PRELIMINARY DRAINAGE REPORT
for
THE COMMONS AT FALCON FIELD

PCD FILE NO. SP-232

Drexel, Barrell & Co.
101 Sawatch Street, #100
Colorado Springs, CO 80903
Contact: Tim McConnell, P.E.
(719) 260-0887

**CLOMR
 FLOODPLAIN
 WORK MAP**

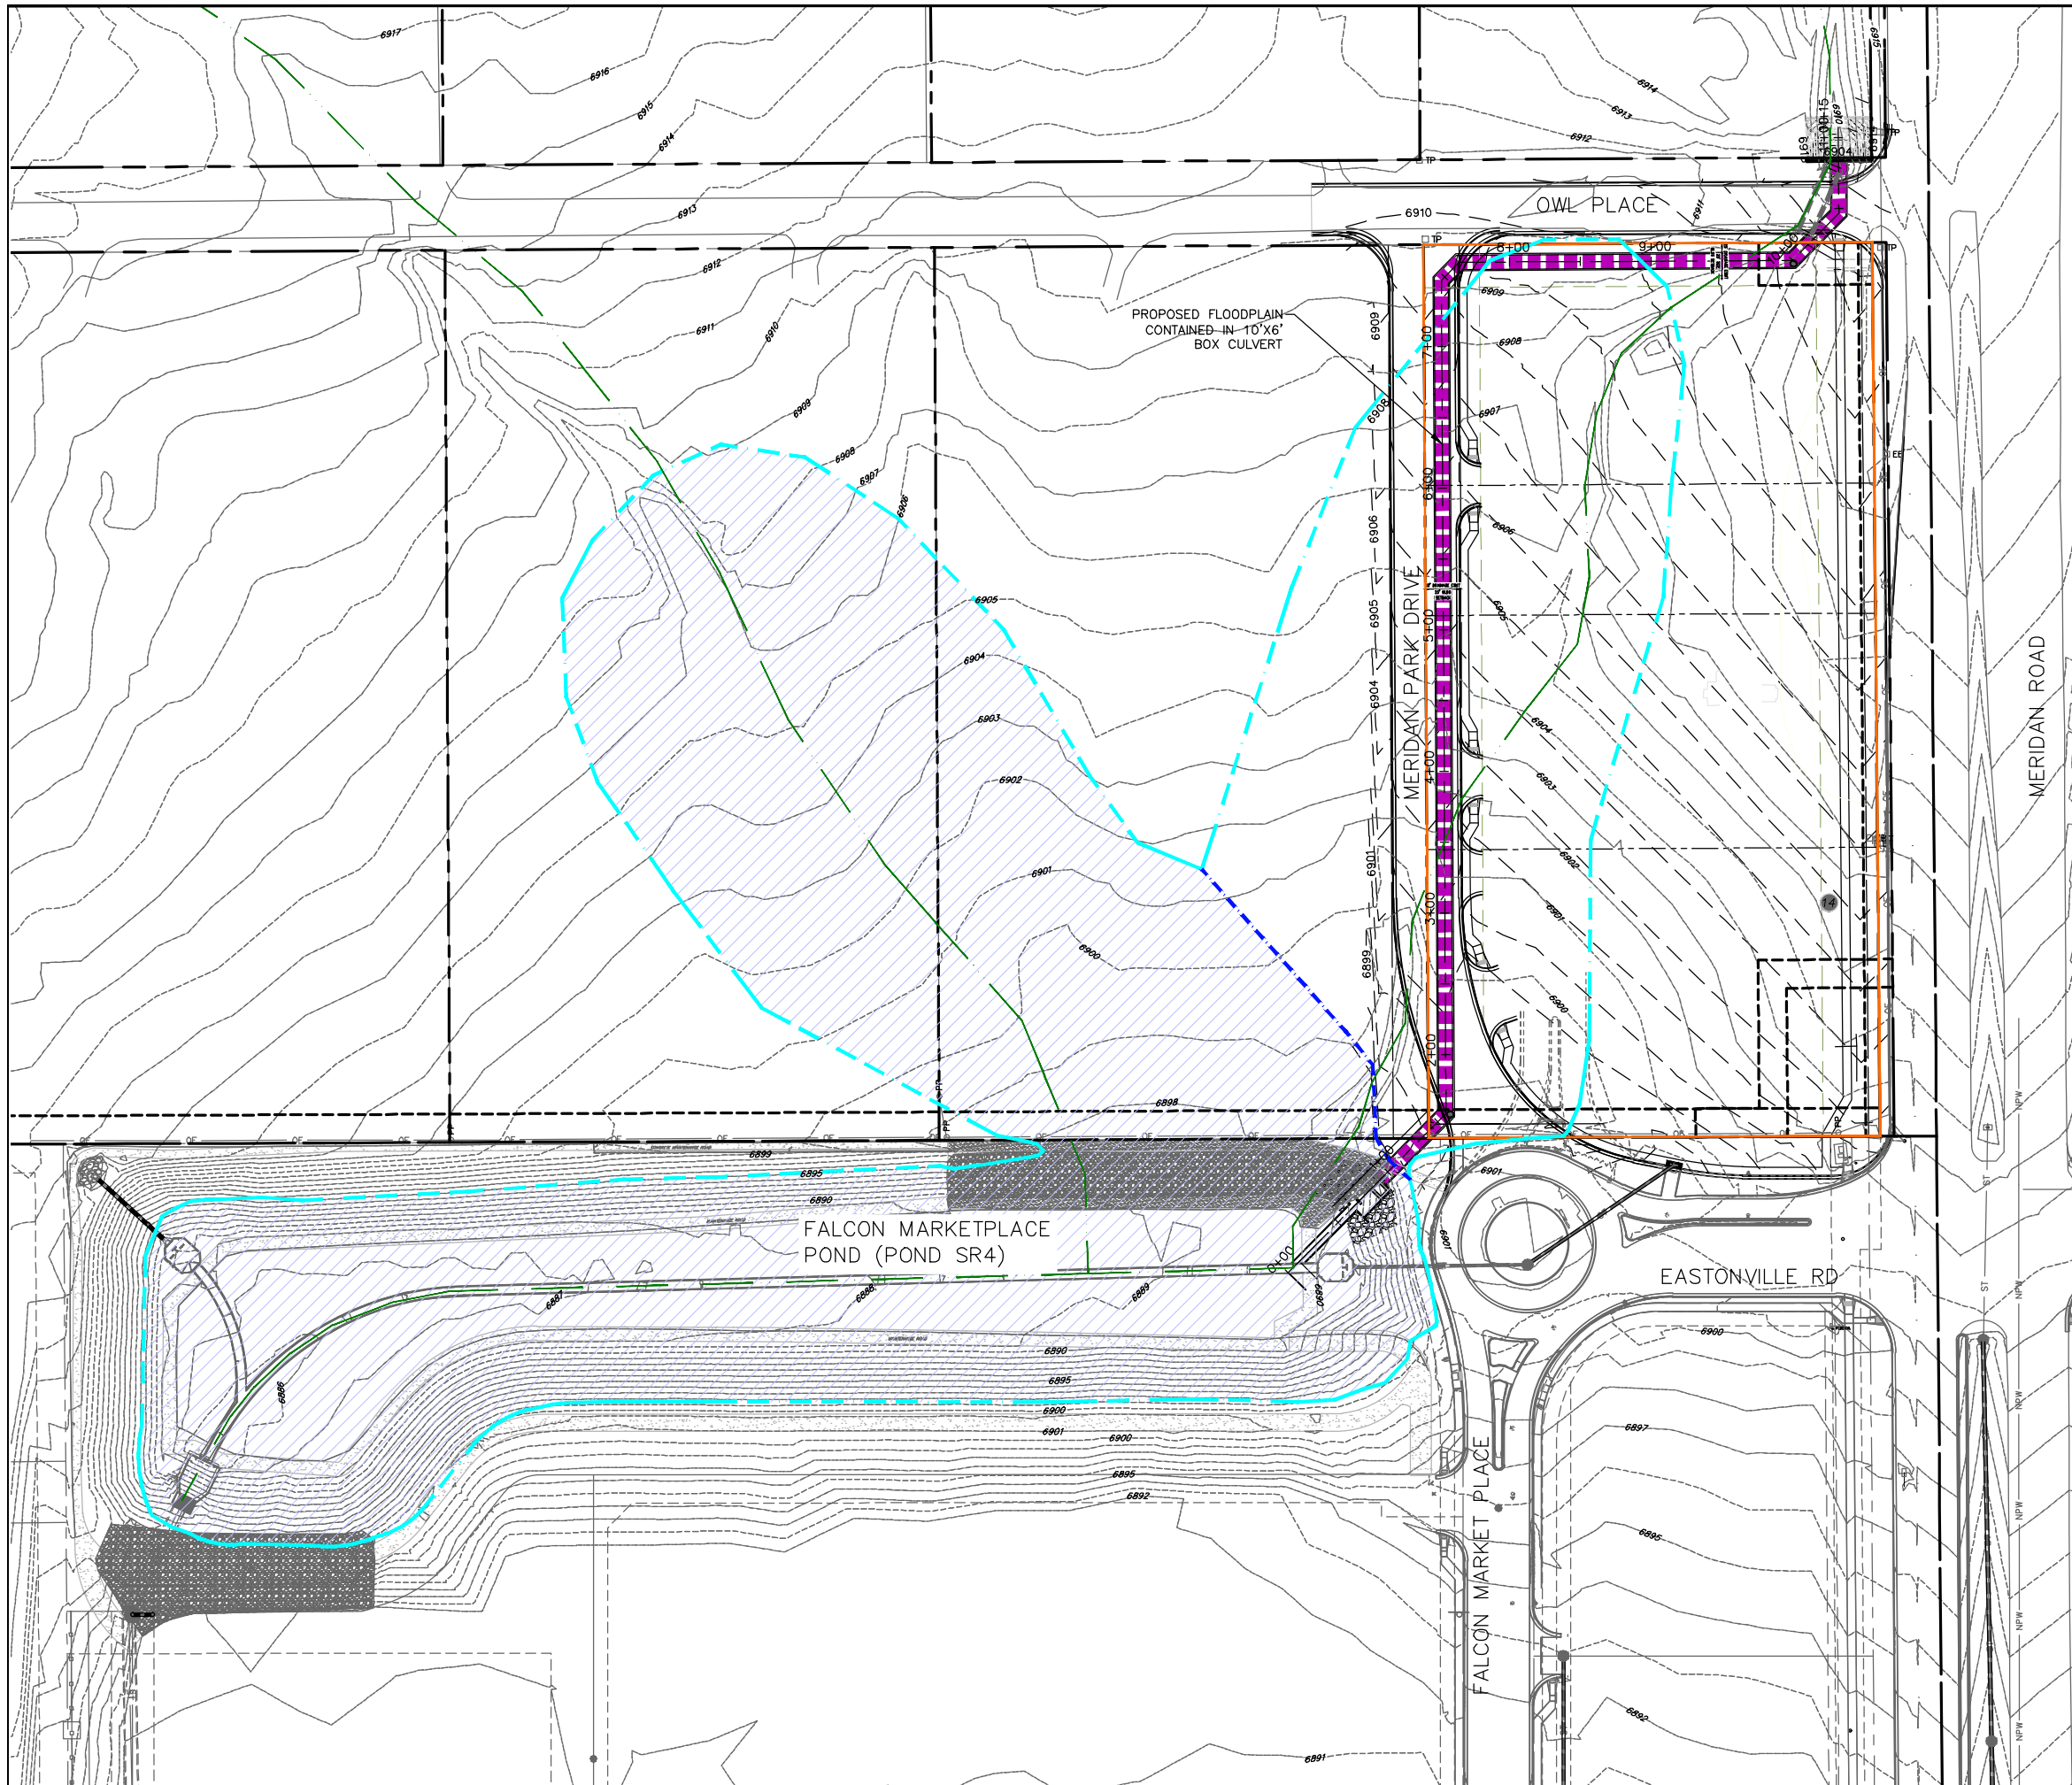
4. Our review of the submitted certified topographic work map entitled, "CLOMR Floodplain Work Map," prepared by Drexel, Barrel & Co., dated May 2022, revealed the following issues. Please submit a revised work map that has been certified by a Professional Engineer registered in the State of Colorado (P.E.).

- a. Our review revealed the proposed floodplain boundary does not follow contours. Please show smooth graphical tie-ins between the proposed and effective flood hazard boundary delineations at the upstream end of the revised reach. Please ensure that the proposed delineations tie-in directly to the effective delineations and follow the proposed conditions topographic contours. Please ensure enough contours are provided to verify the placement of the proposed floodplain delineation.

- b. Please remove the historic effective floodplain delineation, labeled "Effective 100-YR Floodplain", and only show the currently effective delineation from LOMR 21-08-0534P.

- c. Please show the proposed topographic contours in a different color than the existing contours and show how the proposed contours tie-in with the existing.

- d. Please submit a revised work map that has been certified by a registered P.E.

Contours have been added to the work map for clarity.

The proposed topographic contours were added to the work map and differentiated from the existing contours by line type.

The revised work map is provided and stamped.

EDR1

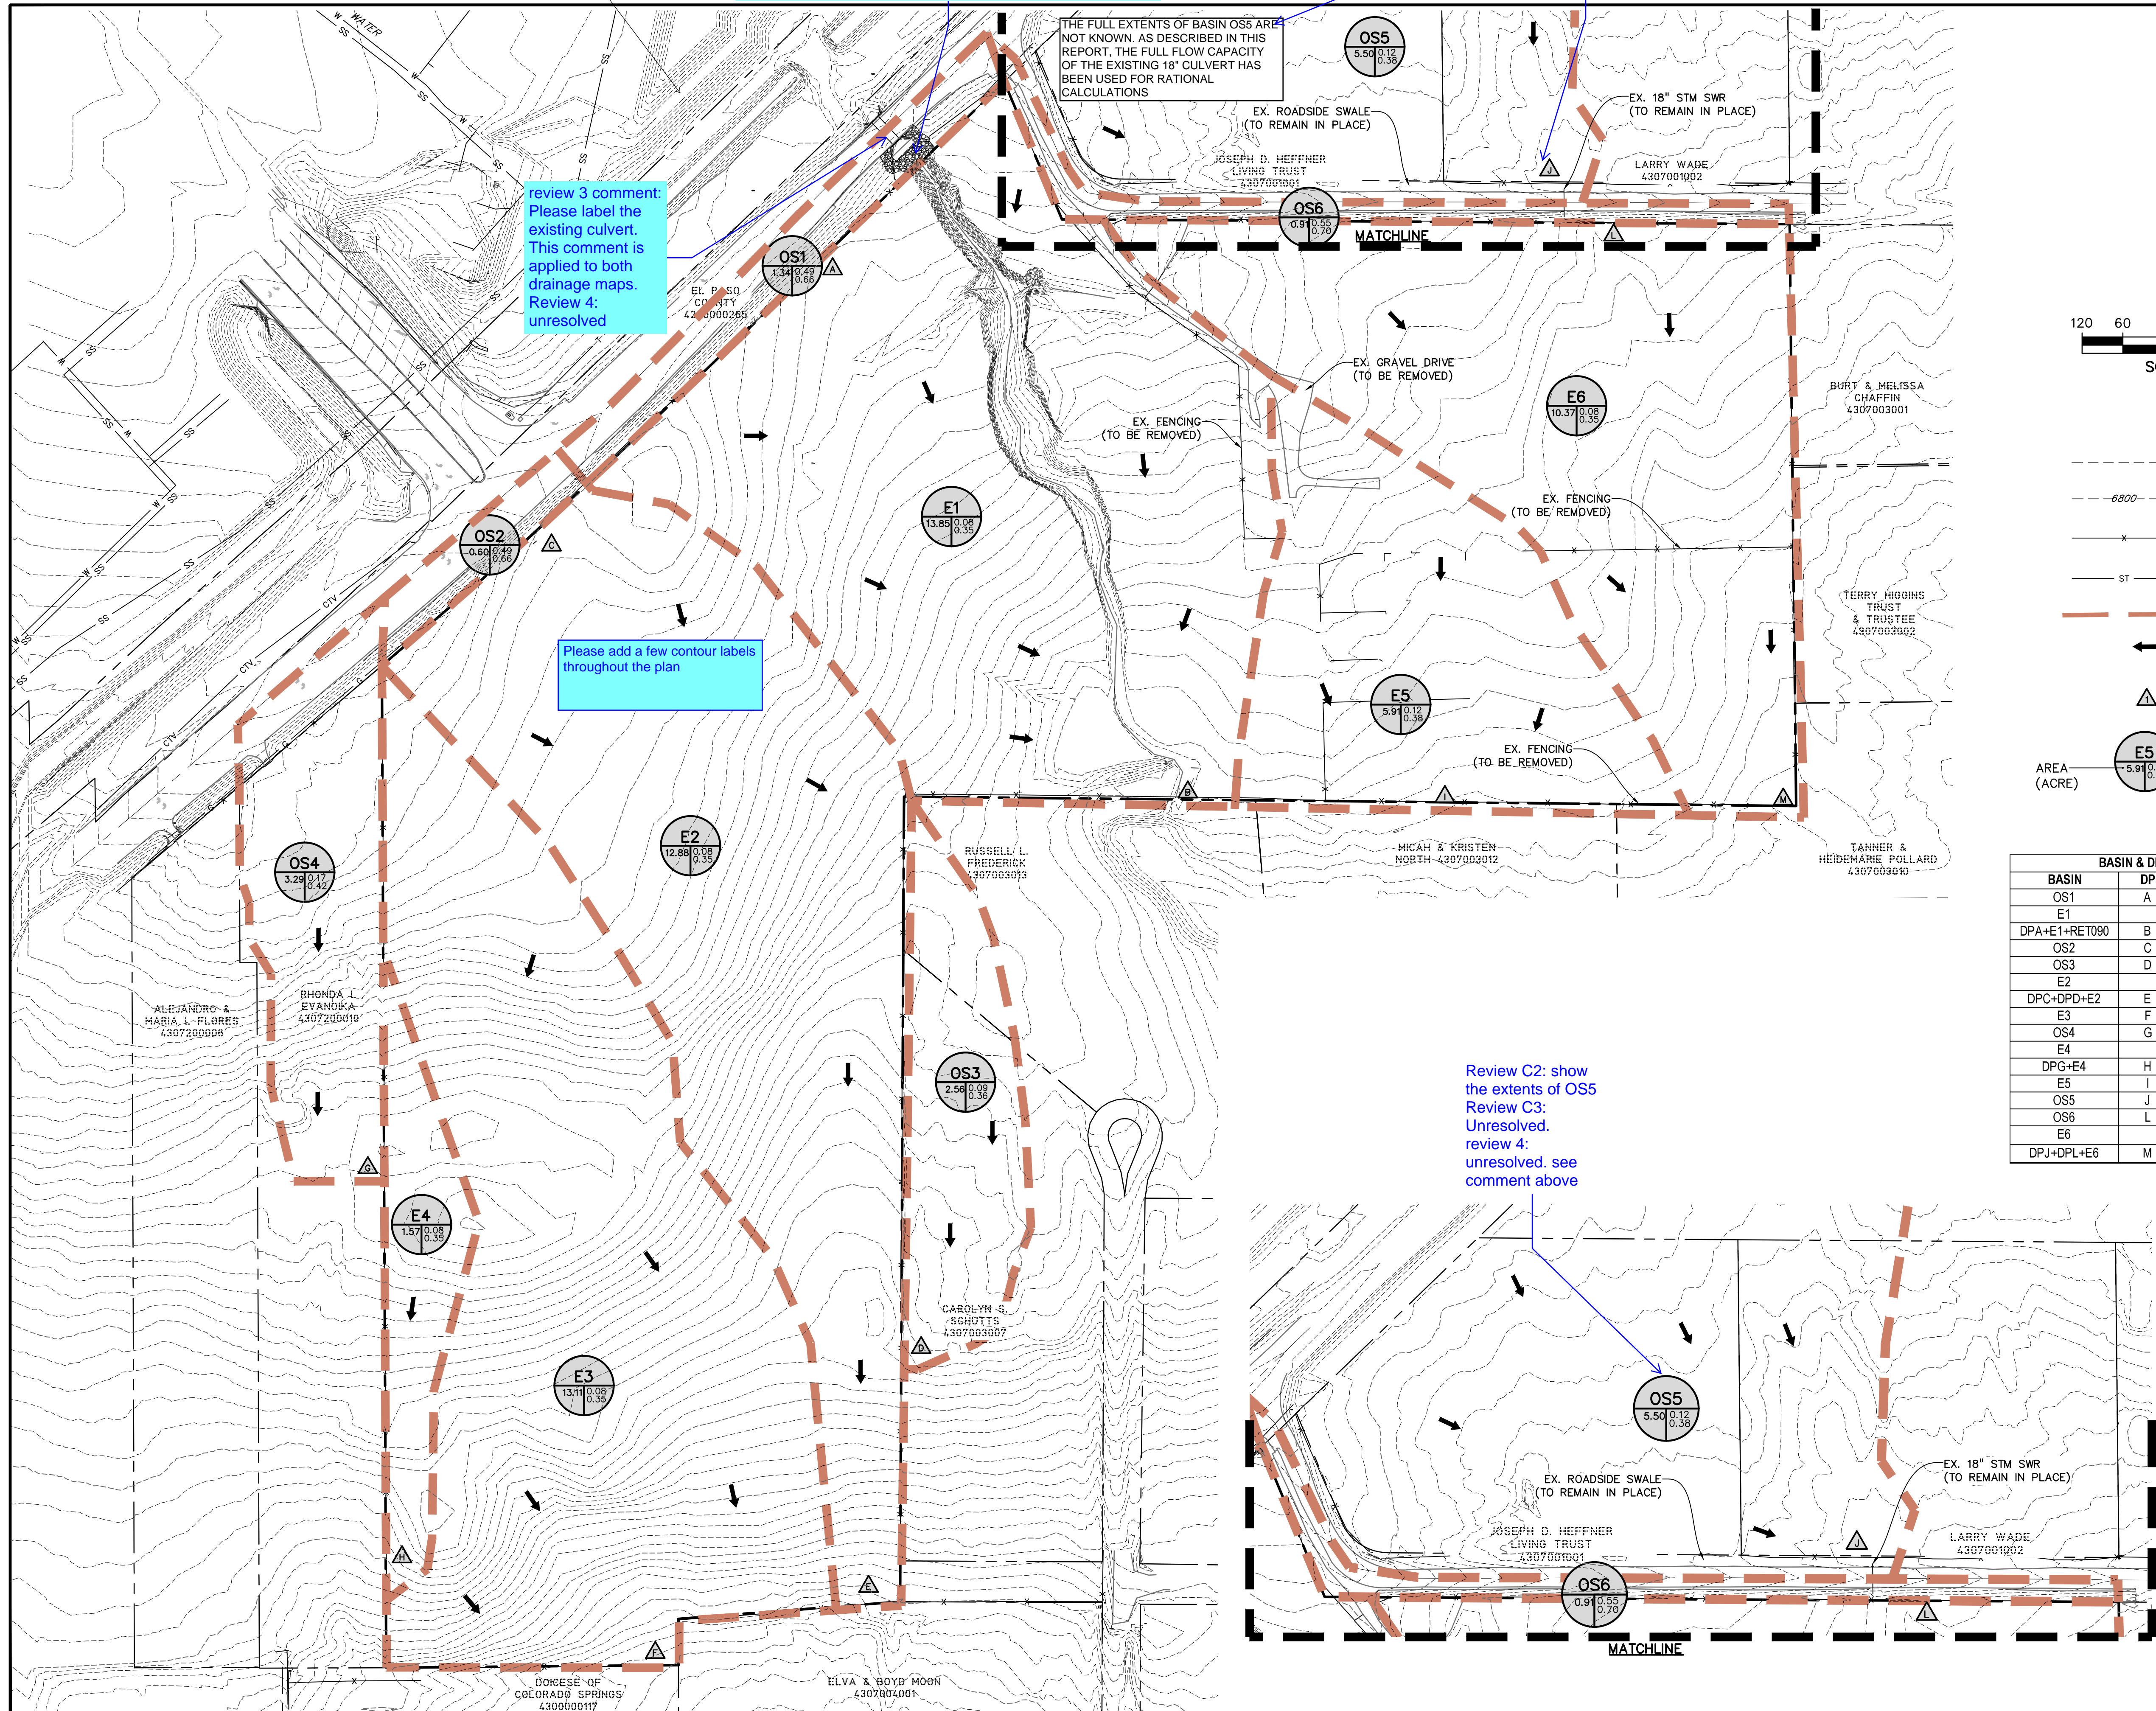
Unresolved from Submittal 3: this should be included as an offsite basin. At a minimum reference the DBPS off-site basin.

Review C2: identify the flow entering the site from the upstream through the existing culvert.
 Review C3: Unresolved. Please discuss off site flows that affect the subject project for both drainage conditions.
 Review 4: Please provide a Design point for the offsite flow outfalling into the site.

Review C2: show the extents of OS5
 Review C3: Unresolved.
 review 4: unresolved. see comment above
